Hunter Valley Energy Coal Pty Ltd
Mt Arthur Coal
Thomas Mitchell Drive
Muswellbrook NSW 2333 Australia
Private Mail Bag No. 8
Muswellbrook NSW 2333 Australia
Tel +61 2 6544 5800 Fax +61 2 6544 5801
bhpbilliton.com

Mt Arthur Coal Mine Operations Plan FY20 – FY22:

Table 1. Rehabilitation Management Plan comments

Mt Arthur Coal: Rehabilitation Management Plan

| Figure 7. Cross Sections Windmill Pit | 34 |

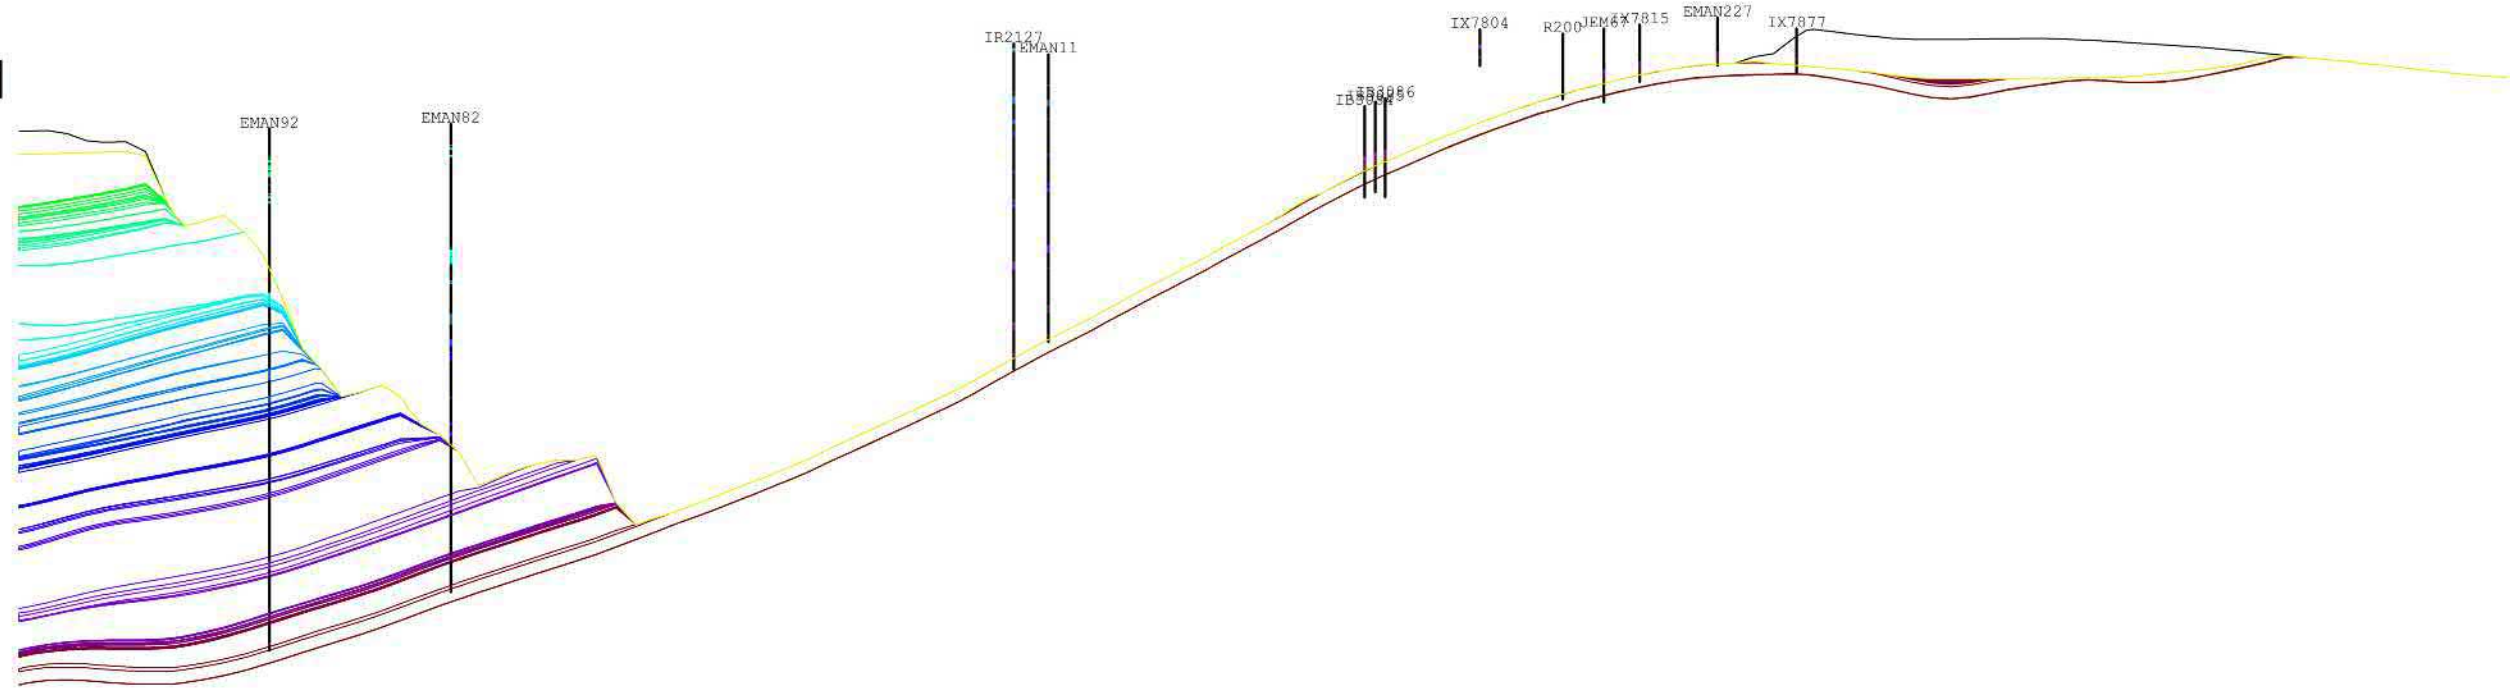
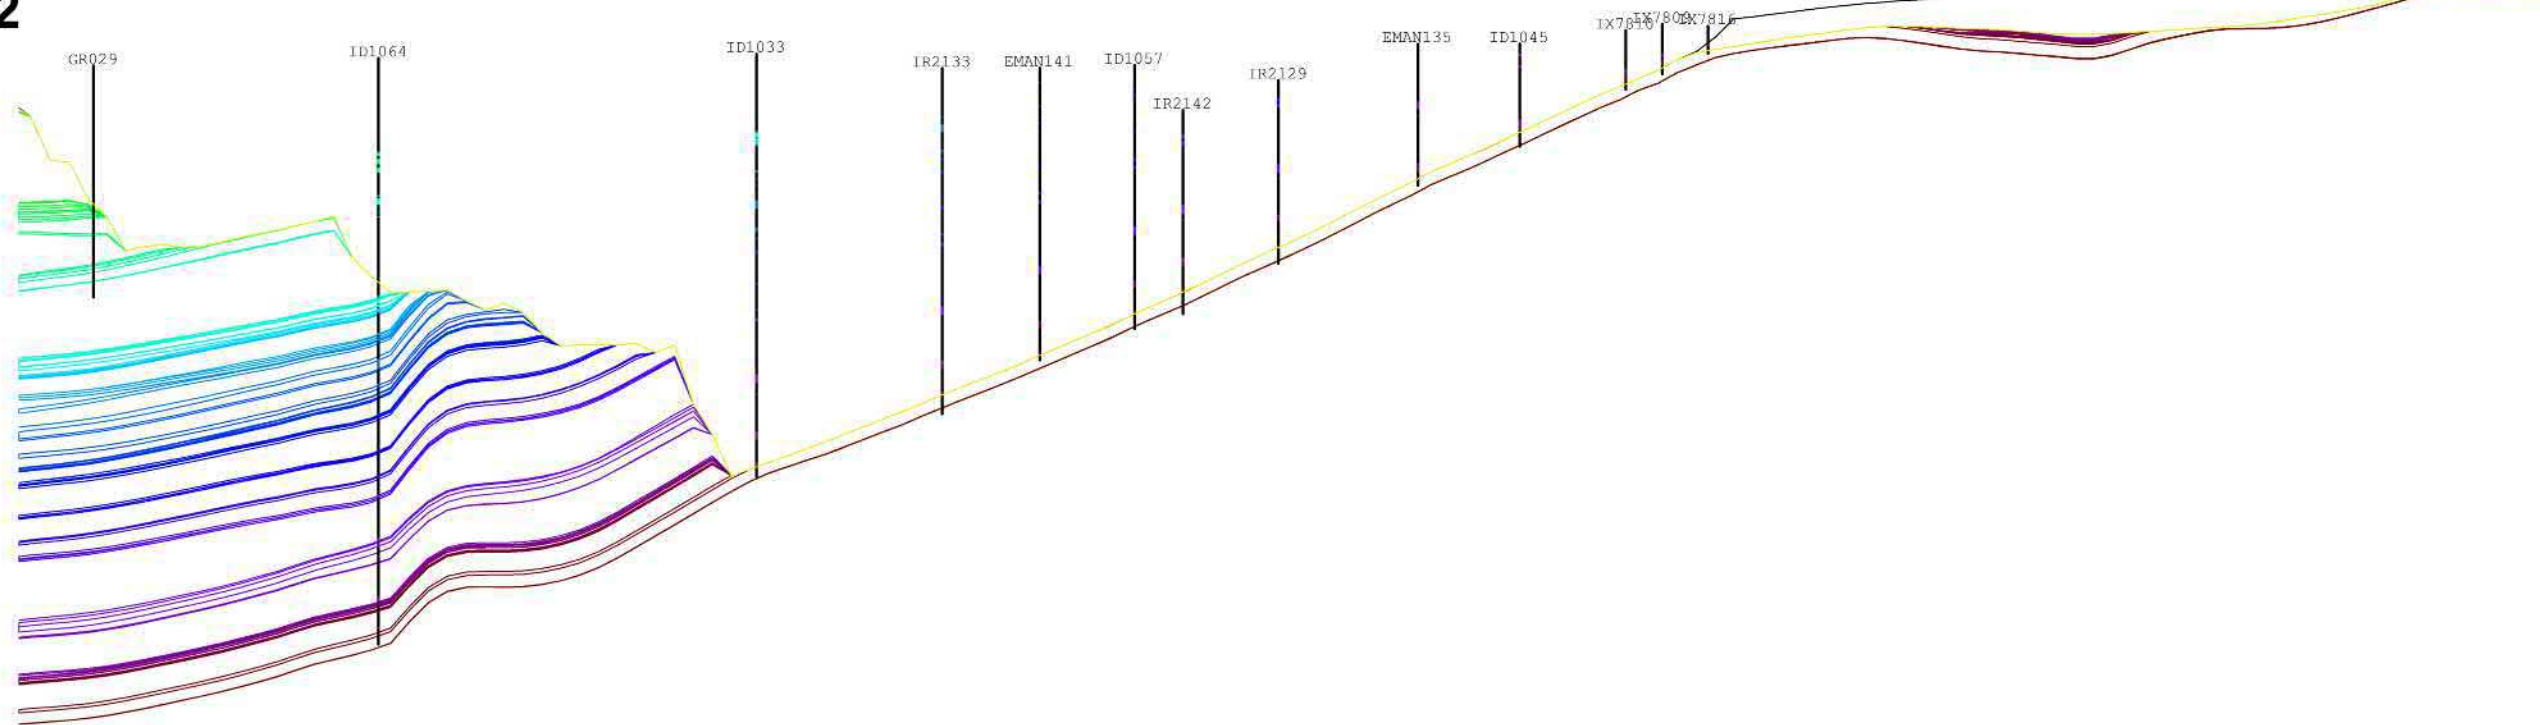
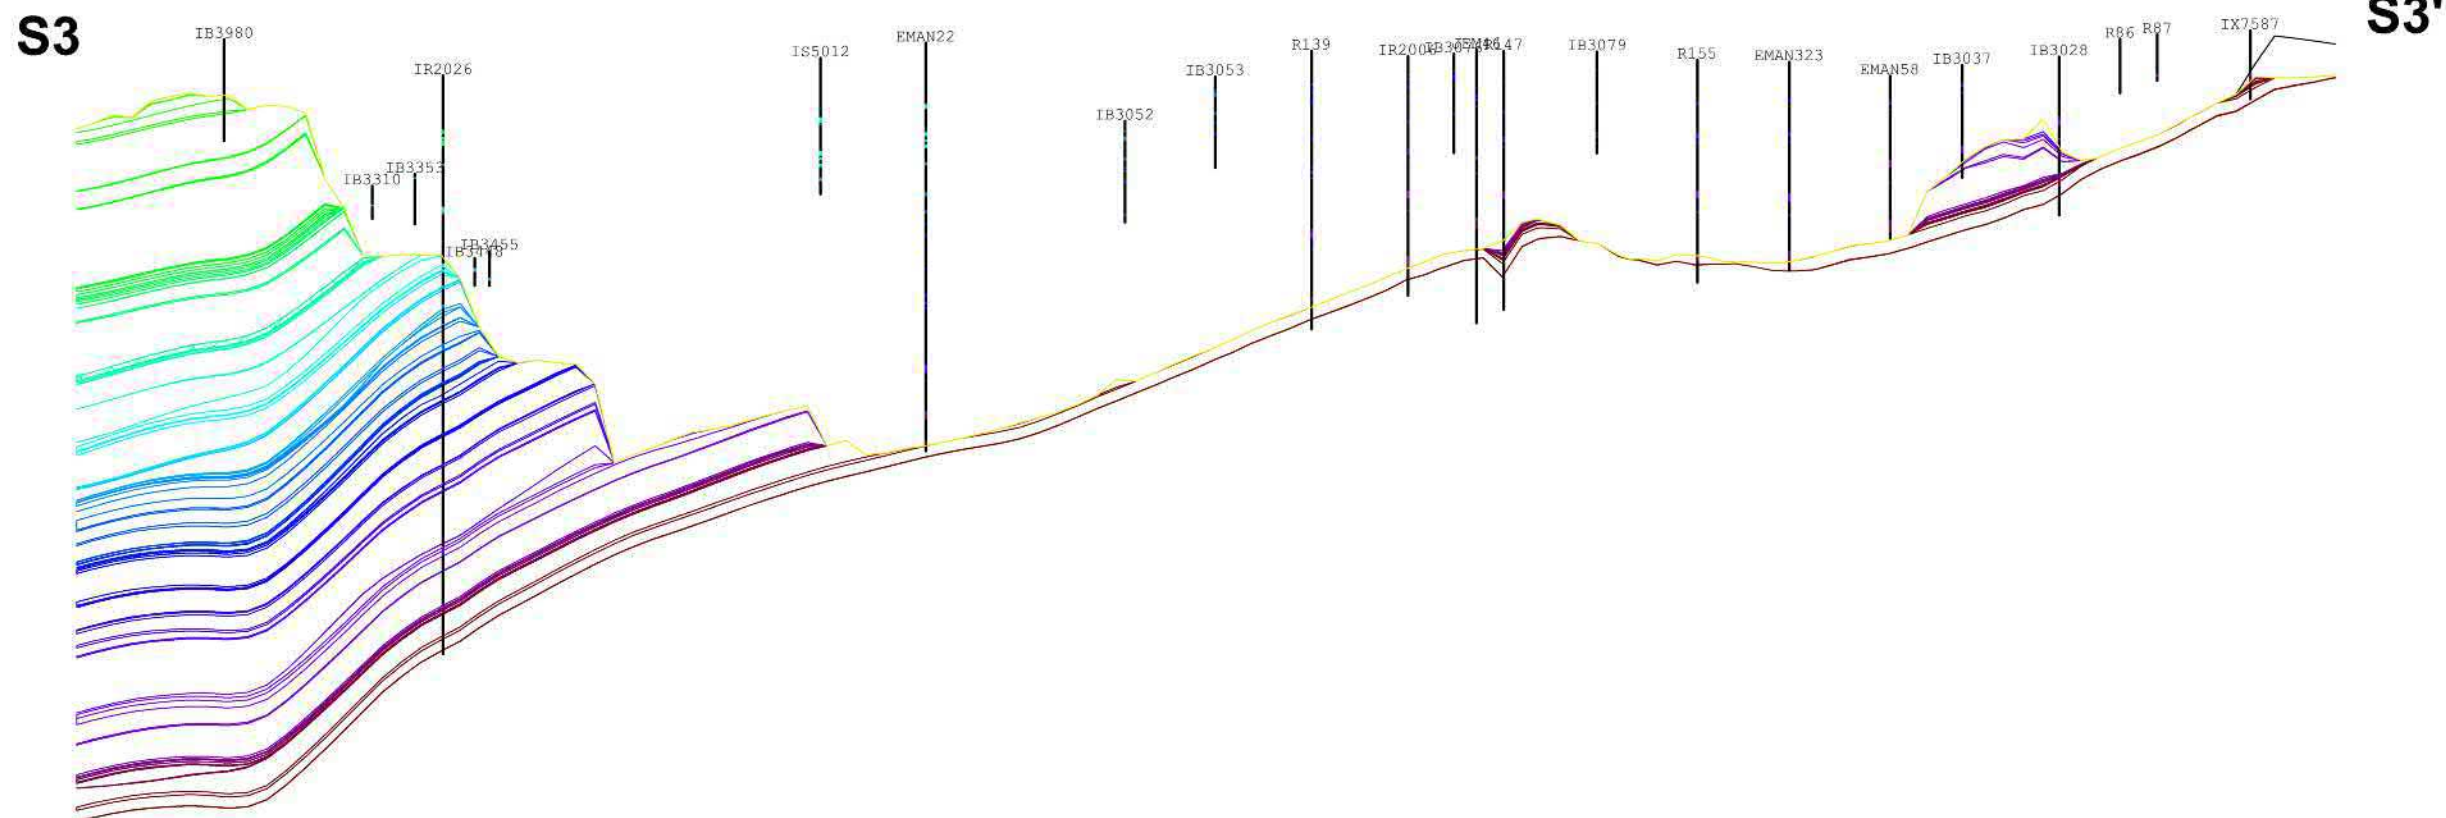
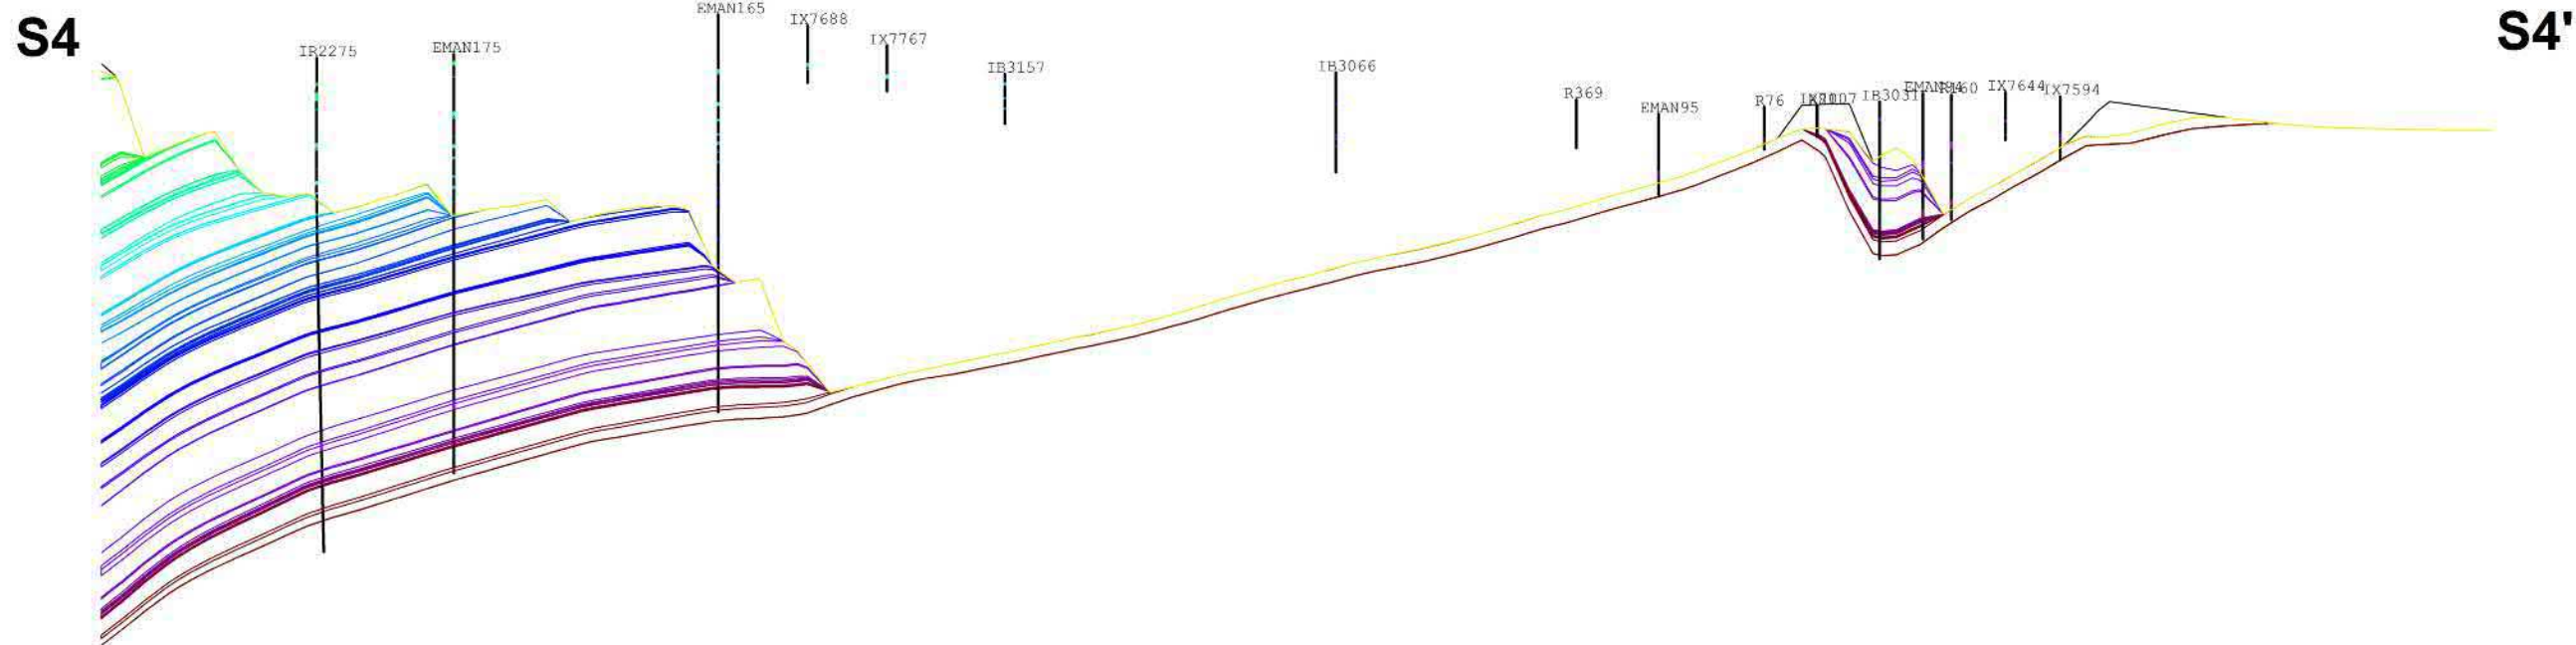
| Please provide higher resolution figures for Figures 7 and 8 | Updated figures in final RMP version |

| 60 | Figures 7 and 8. Figure legends are not legible | <ul style="list-style-type: none"> HVEC will amend figures to ensure legends are legible. |

| Please provide higher resolution figures for Figures 7 and 8 | Updated figures in final RMP version |
